**COUNCIL ACTION FORM**

**SUBJECT: APPROVAL OF HEARTLAND SENIOR SERVICES PROPOSED SITE PLAN & ELEVATIONS FOR 205 SOUTH WALNUT**

**SITE DEVELOPMENT PLANS & ELEVATIONS:**

# Attachment B- Site Layout, Floor Plan, Landscaping

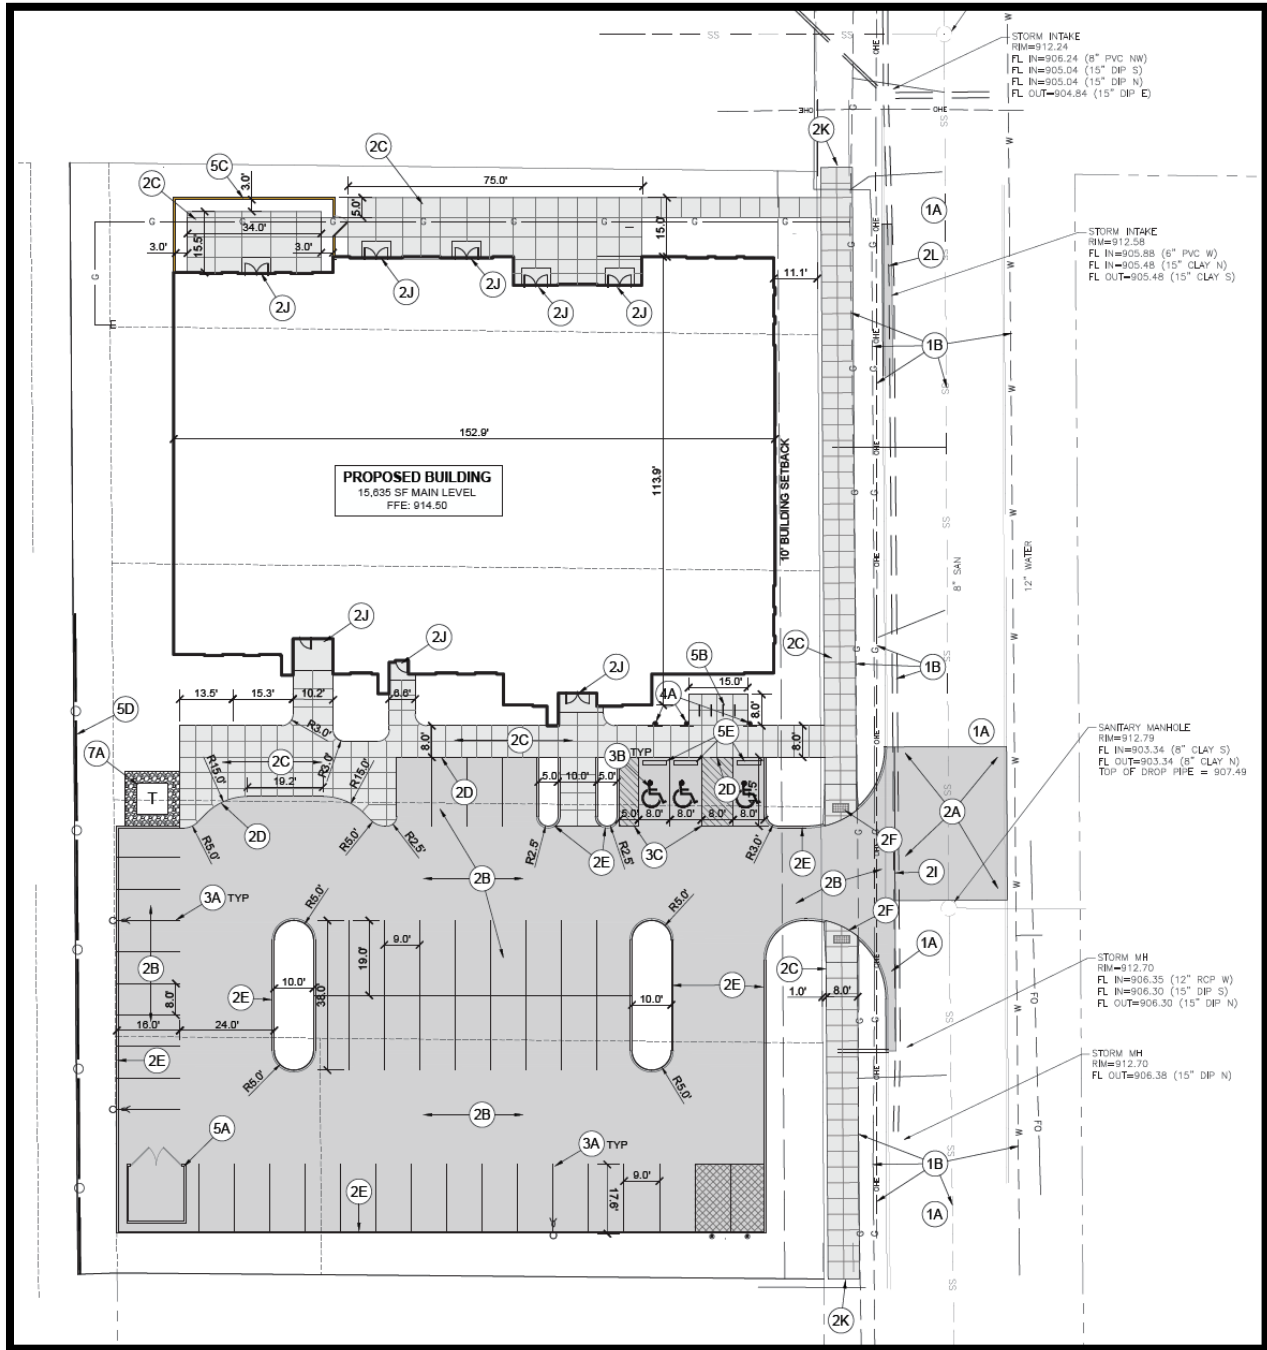
The site layout consists of one single driveway access point at the south end of the site and the building situated at the north end of the site. There are two separated entrances to the building, both of which face south to the parking lot. The east façade (front façade) of building along Walnut includes windows and brick materials, but it does not include a building entrance.

The building location is under review with the design team to address utility space along the western (rear) boundary. The proposed concept accommodates utility space to the rear and has an 11-foot front yard setback. The general arrangement of the site and layout of the building will not significantly change with the final choice of building location. Within the NC zoning district, building facades without street entrances have a front setback of 10’. Facades with a building entrance can be reduced to zero. The building as shown does meet the required NC setbacks.

The parking is consolidated to the south end of the site maximizing the use of the site to its fullest. There is one access way into the parking lot from S. Walnut. The design of the parking lot provides for convenient flow of vehicles and movement of pedestrians and will prevent hazards to adjacent streets or property. The parking is configured as two double loaded aisles across the south portion of the site. There is also a drop-off lane at the entrance to the Adult Day Care. The parking lot will include lighting.

**Parking for the site requires a City Council determination of appropriateness for the mix of uses. Heartland has indicated that the adult day care patrons do not drive and to apply a parking rate to the gross floor area of the space would be inappropriate.** A drop-off lane is provided at the entrance to this portion of the facility. "Adult Day Care" is not a category within the table of parking requirements. The closest similar use classification is "Nursing and Convalescent Homes" which require 1 space/5 beds, plus 1 space/2 staff members of the largest shift. Heartland indicates that this portion of the building will have seven employees. Required parking for this portion of the facility is calculated based upon the number of employees, which is seven.

The site accommodates a total of 49 parking spaces, which includes: 2 electric charging stations (or general use), 3 ADA compliant spaces, and 44 regular spaces. Although on street parking could be counted towards the site totals by zoning, there is no parking permitted along Walnut. Overflow parking would have to occur on an adjacent commercial property or on South 2<sup>nd</sup> Street to the east of the site. Based upon the noted area for each use, the project requires a total of 63 parking spaces. **The calculated number of parking spaces for comparable uses is greater than the parking spaces that are being provided.**

To add more parking to the site would require either a change to a two-story building or a reduction in square footage of the building for community center uses. However, **with City Council's concurrence on the described uses and planned intensity of use as meeting the City's objective for leasing the site for a senior facility, City Council can find the proposed parking spaces, while less than a commercially established building, is the practicable amount of parking on site available to serve the use.**

The review is also to determine if strict compliance is required with the table of parking regulations and with the NC development standards. Staff finds that the proposed use with its site layout, parking supply, and architectural design can be found consistent with the S-GA zoning expectations for compatibility and conformance to comparable zoning district standards of NC.

**Therefore, it is the recommendation of the City Manager that the City Council act in accordance with Alternative #1, which is to approve the initial building and site improvement plans for Heartland Senior Services at 205 So. Walnut Street.**

**FLOOR PLAN**  
SCALE: 1/8" = 1'-0"

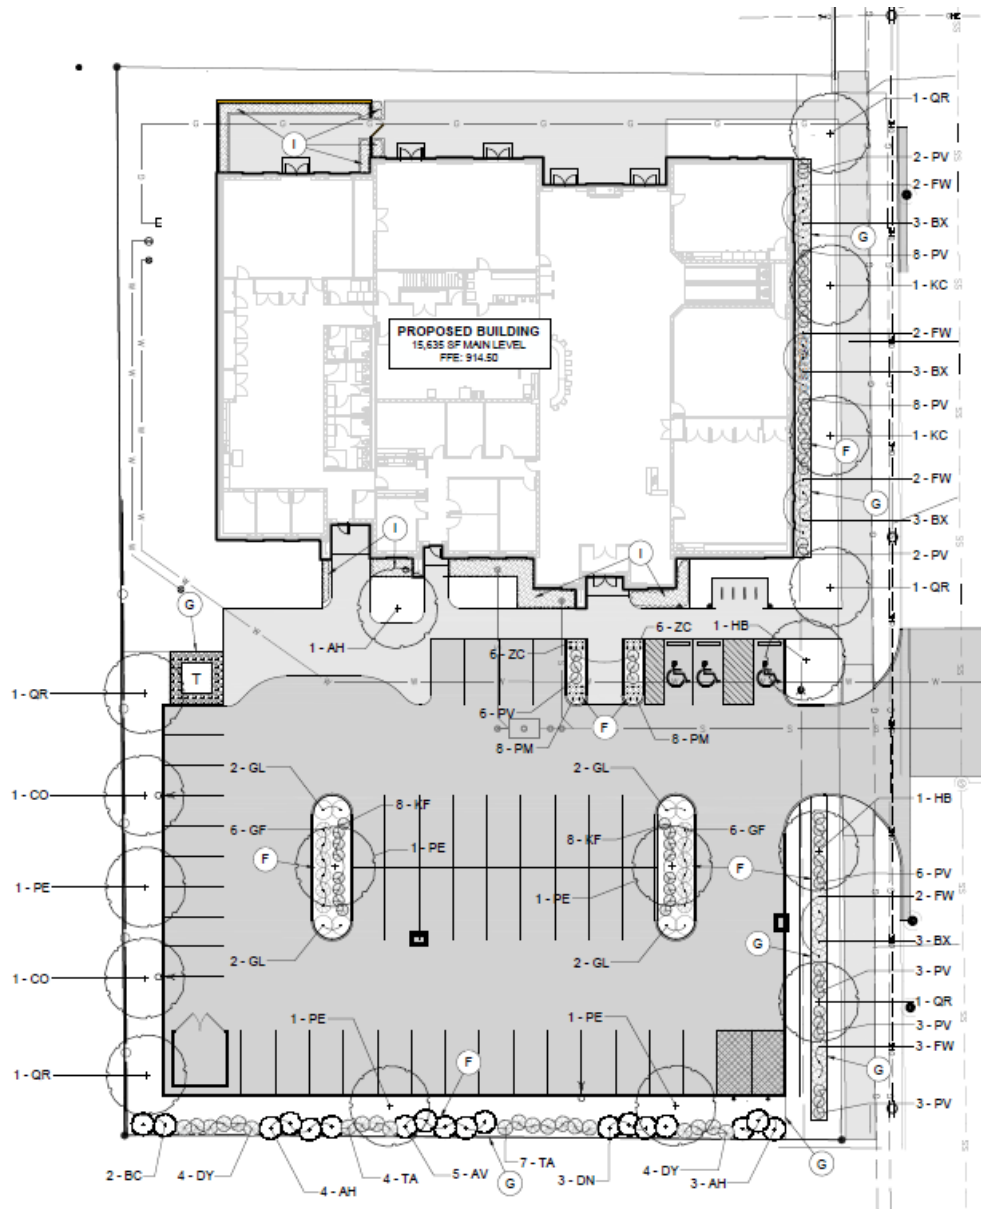
The building is proposed as a one-story structure with a mezzanine. The main level of the facility includes 15,635 sq. ft., composed of adult day care (3,960 sq. ft.), offices (1,760 sq. ft.), and community center (9,915 sq. ft.). The community center area is proposed to include a multi-purpose/meeting room, hobby hub, cardio/strength workout area, fitness studio, bistro, catering area, restrooms and common gathering areas. The portion for the adult day care is approximately 1/3 of the total area and is enclosed and separated from the general use area. The facility will be used both during the daytime and evening.

The primary building entrances are oriented to the south facing the parking lot. There is an entrance to each of the use areas of adult day to the rear and community space to the front. The most prominent entrance, including a vestibule, leads to the community center.
